3 Taxonomy of Optical Access Network Technologies

Figure 1: Various options for a WDM-PON

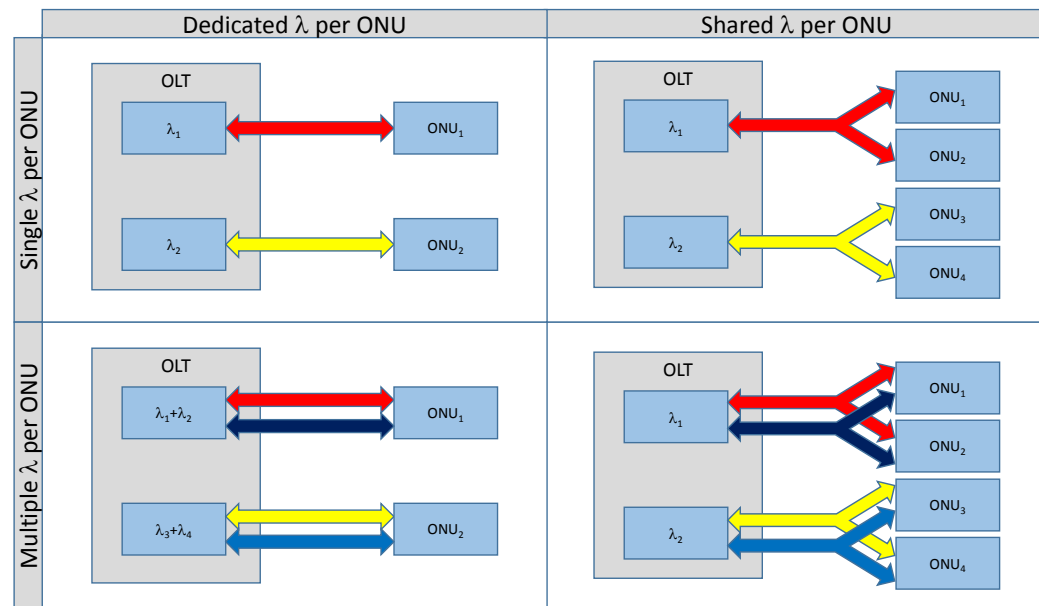
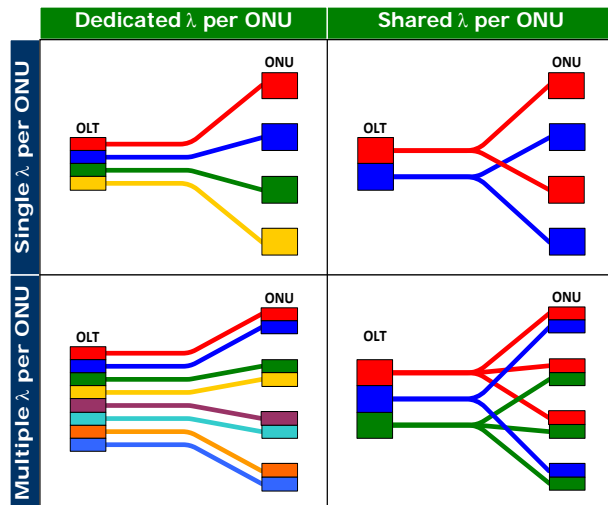
Editorial Note (to be removed prior to publication): each colored link in figure represents a bidirectional wavelength channel.

Figure 2: Upstream channel in MSD-WDM-PON

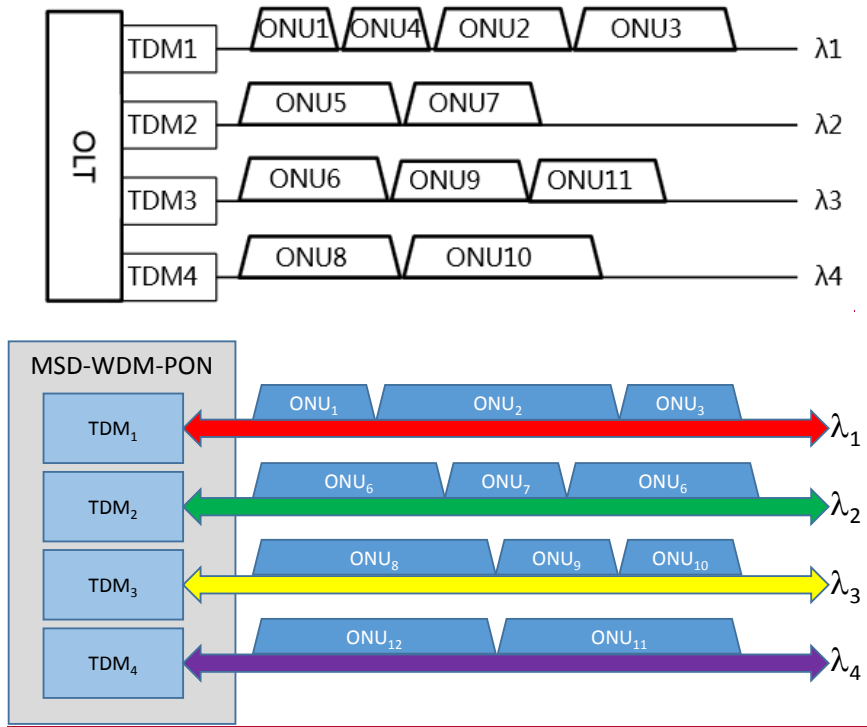
~~The~~In the upstream direction, the OLT then grants access to the assigned wavelength channel to a specific ONU, allowing the ONU to transmit its queued data. The duration of such access to the upstream wavelength channel granted to the given ONU depends on the operation of a Dynamic Bandwidth Allocation (DBA) mechanism. No other ONU is allowed to transmit during the same window of time. On a MSD-WDM-PON each ONU transmits on one and only one upstream wavelength at a time, as illustrated in Figure 32.

Figure 3: Upstream channel in SSD-WDM-PON

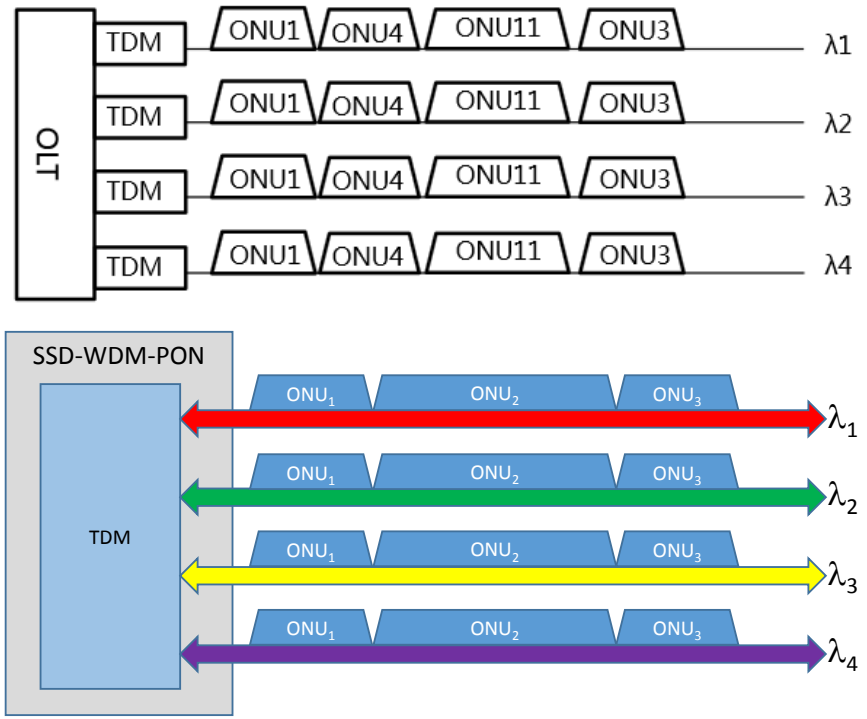
~~The~~In the upstream direction, the OLT grants access to all available ~~upstream~~ wavelength channels to a specific ONU, allowing it to transmit its queued data. The duration of such access to all upstream wavelength channels granted to the given ONU depends on the operation of a DBA protocol. No other ONU is allowed to transmit during the same window of time. On an SSD-WDM-PON each ONU transmits on all upstream wavelength channels at a time as illustrated in Figure 43.

Figure 4: Upstream channel in WA-PON

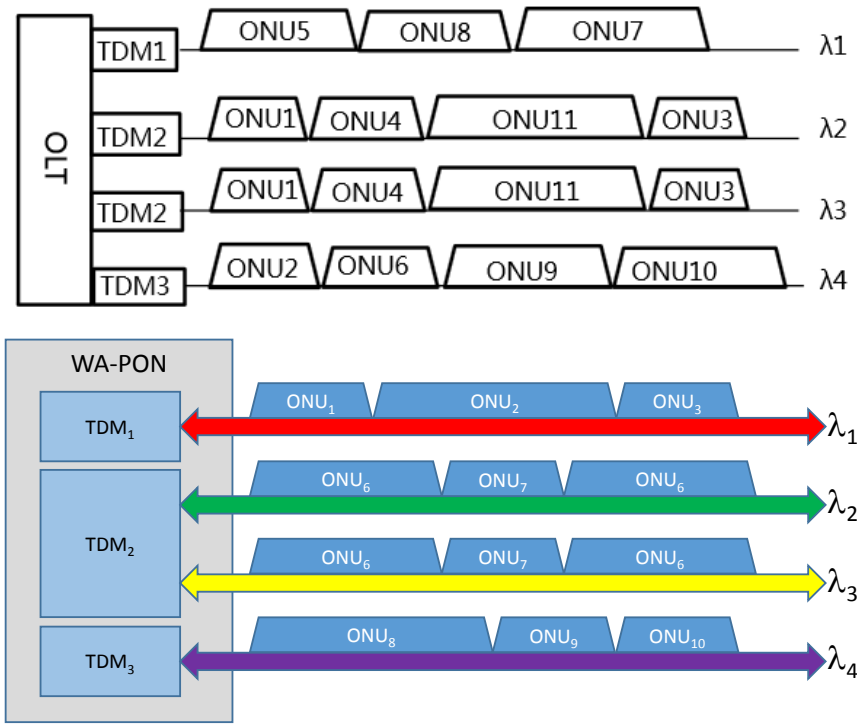
~~The~~In the upstream direction, the OLT grants access to the assigned ~~upstream~~ wavelength channels to a specific ONU, allowing it to transmit its queued data. The duration of such access to the assigned upstream wavelength channels granted to the given ONU depends on the operation of a DBA mechanism. No other ONU is allowed to transmit on the same wavelength channels during the same window of time. Effectively, in WA-PON, each ONU transmits on its allocated upstream wavelengths simultaneously with other ONUs as shown in Figure 54.
